MUNCASTER MILL

PRELIMINARY FOREST CONSERVATION PLAN F20230500

MUNCASTER MILL PROPERTY
PRELIMINARY PLAN NO. 120250130

RE: Preliminary Plan No. 120250130
Muncaster Mill Property
Preliminary Plan Letter

FIRE DEPARTMENT ACCESS PLAN

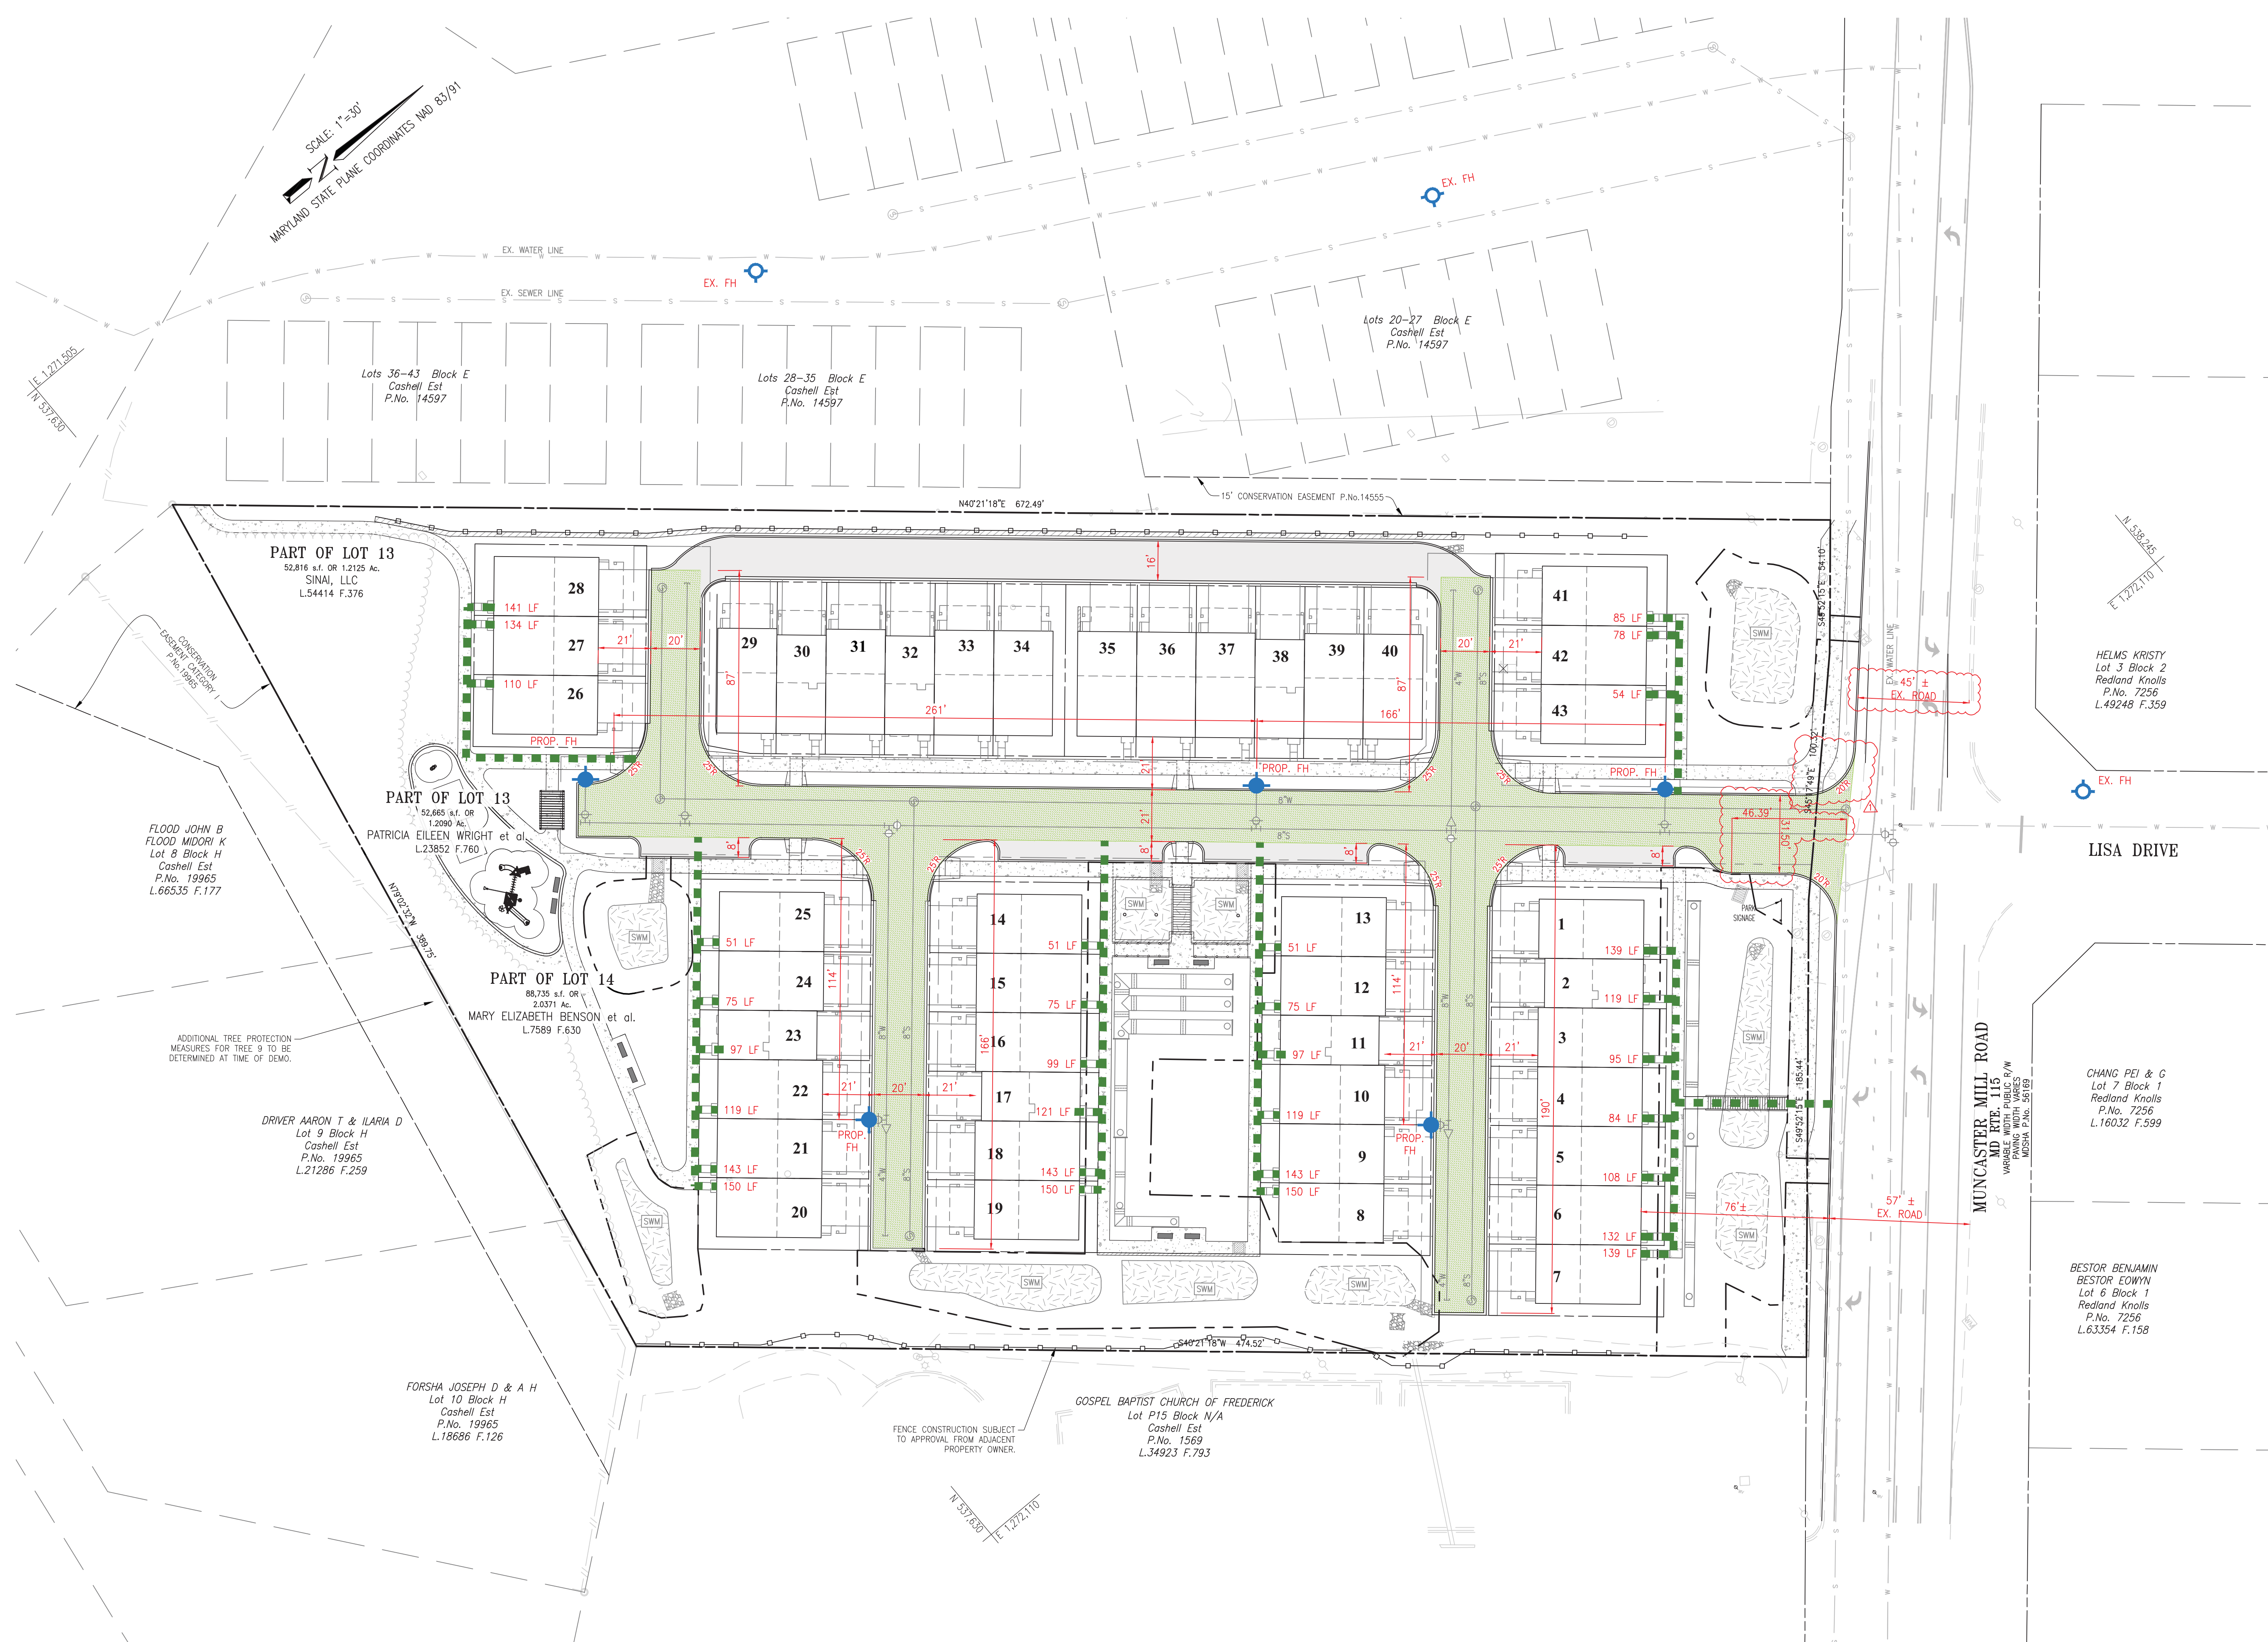
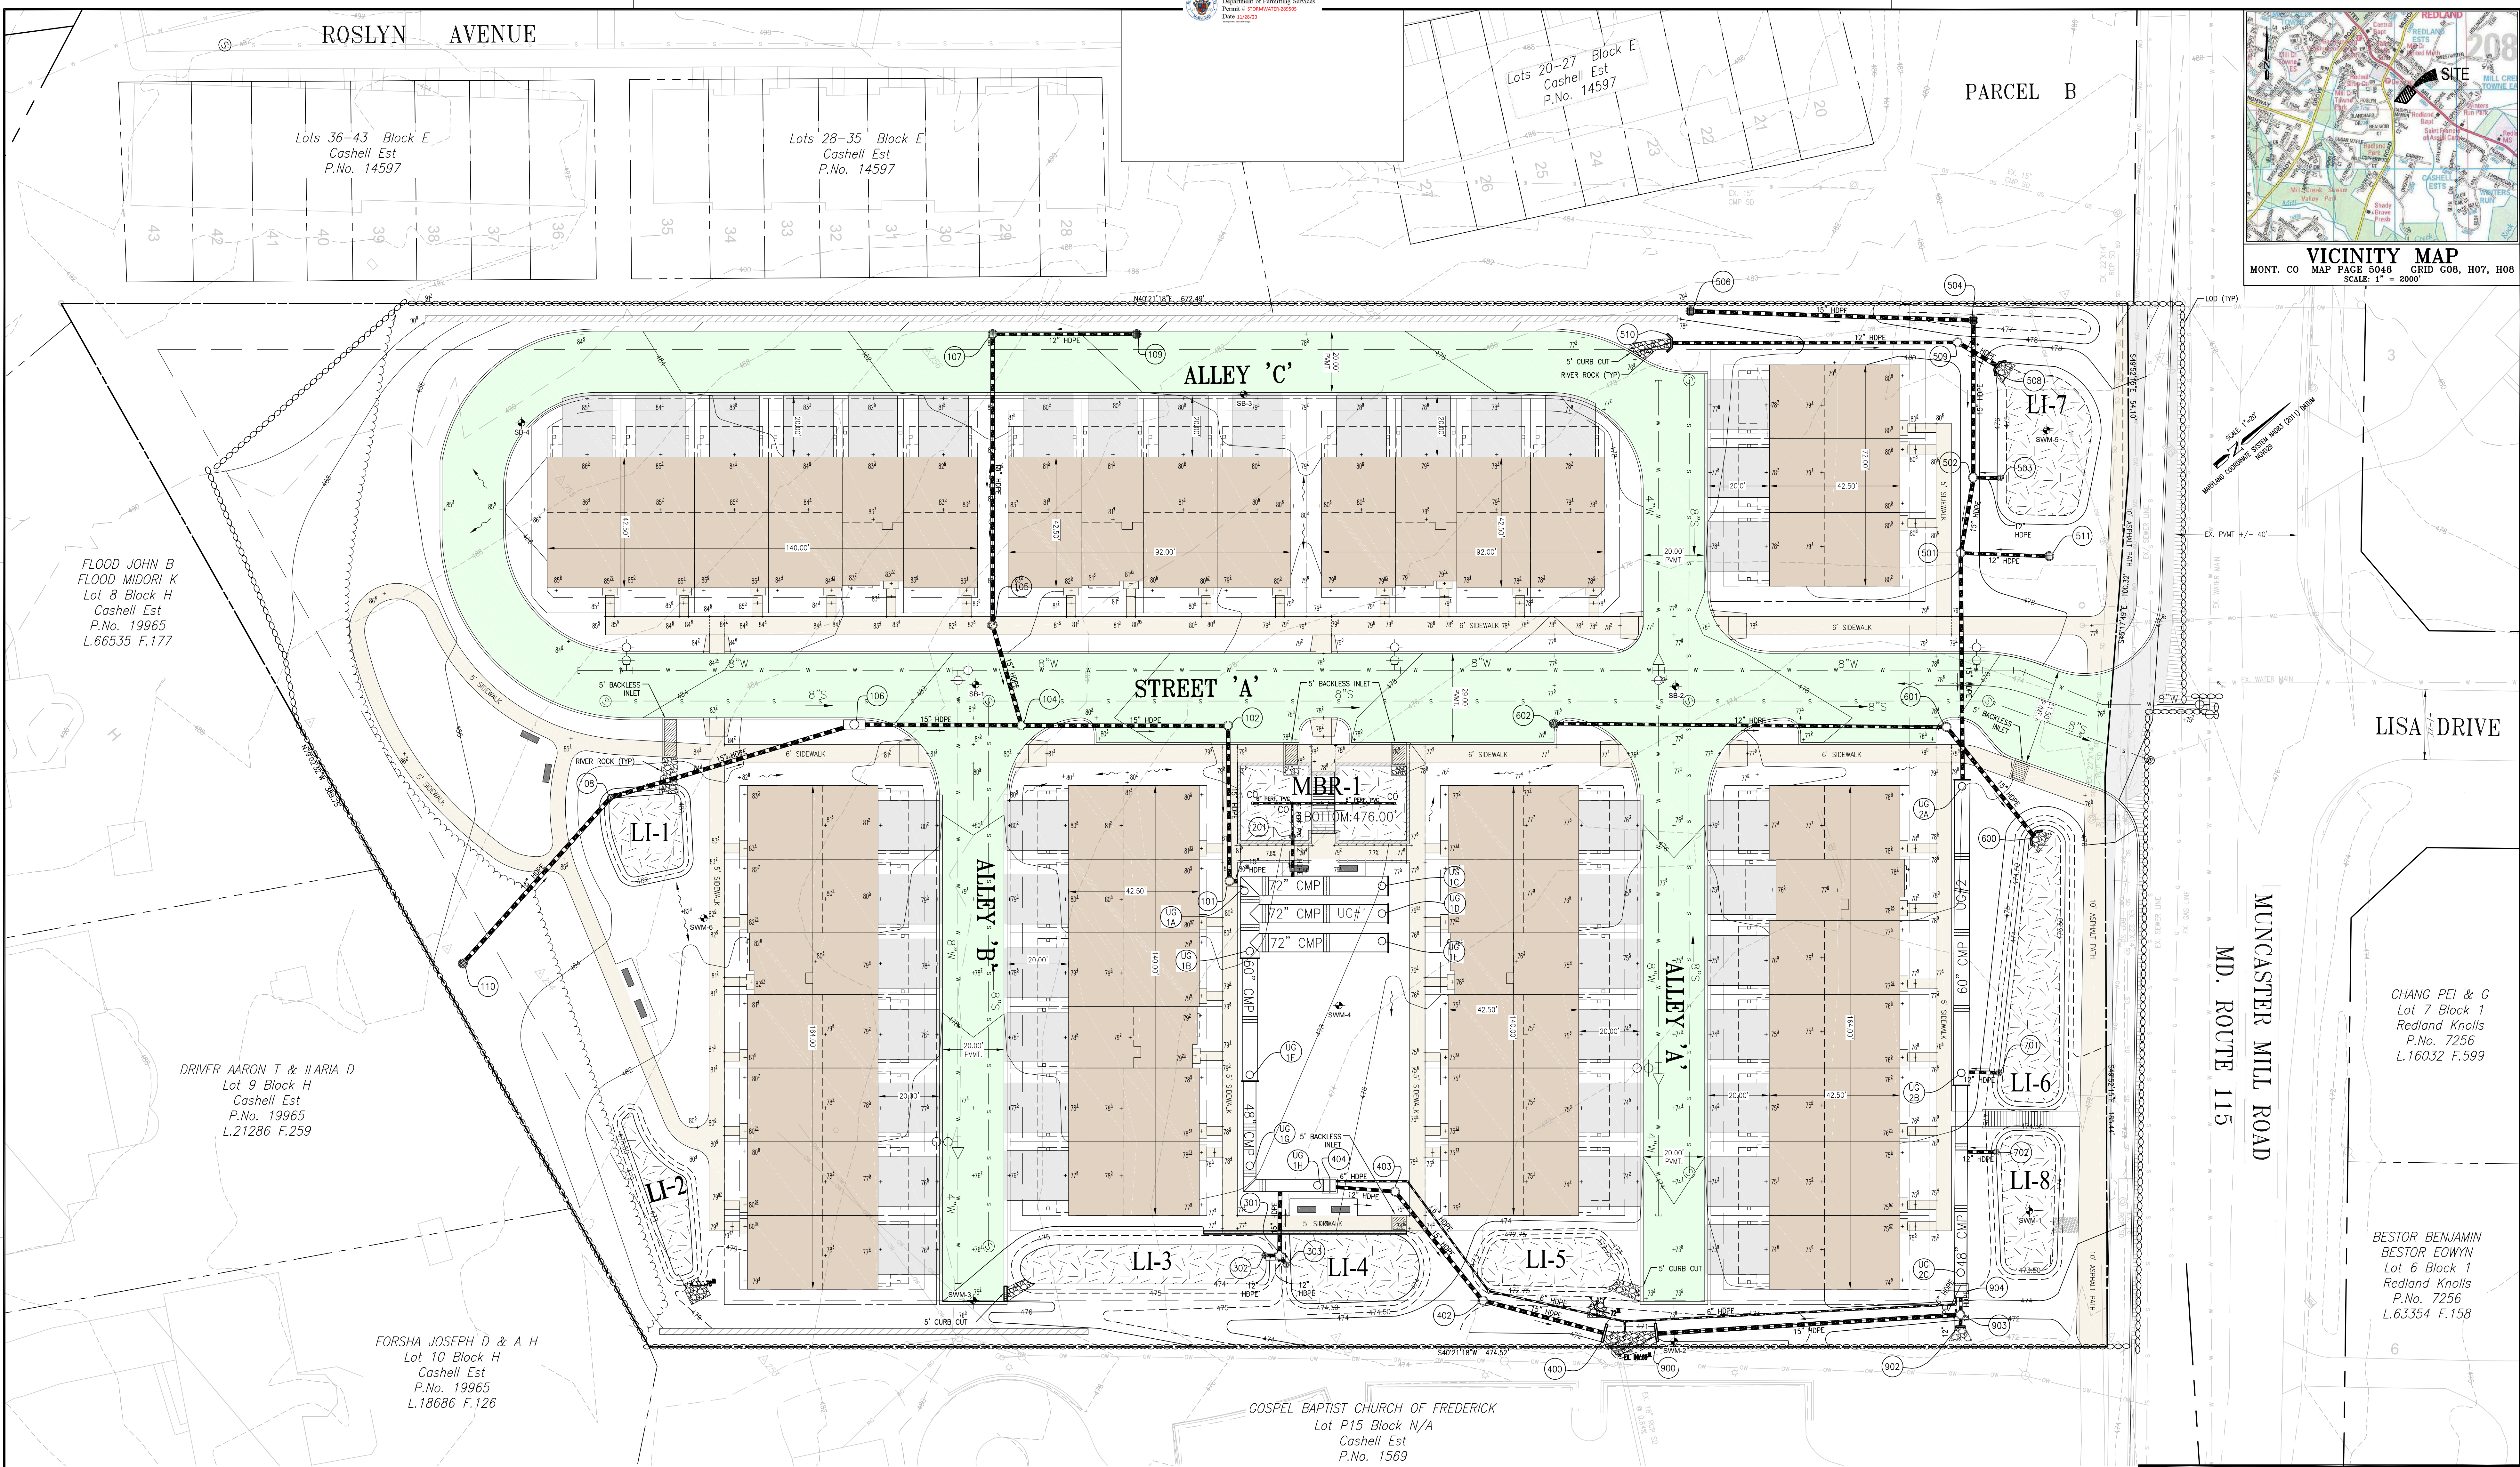
*** Fire lane orders to be processed for execution and installed prior to first occupancy ***

*** 2/20/2025 Approval of revised radii at entrance only ***

UPDATES/REVISIONS:
02/20/25 - RADIUS AT ENTRANCE REVISED TO 20' TO AVOID UTILITY POLE
ADDITIONAL DIMENSIONS PROVIDED TO SHOW PAVEMENT WIDTHS
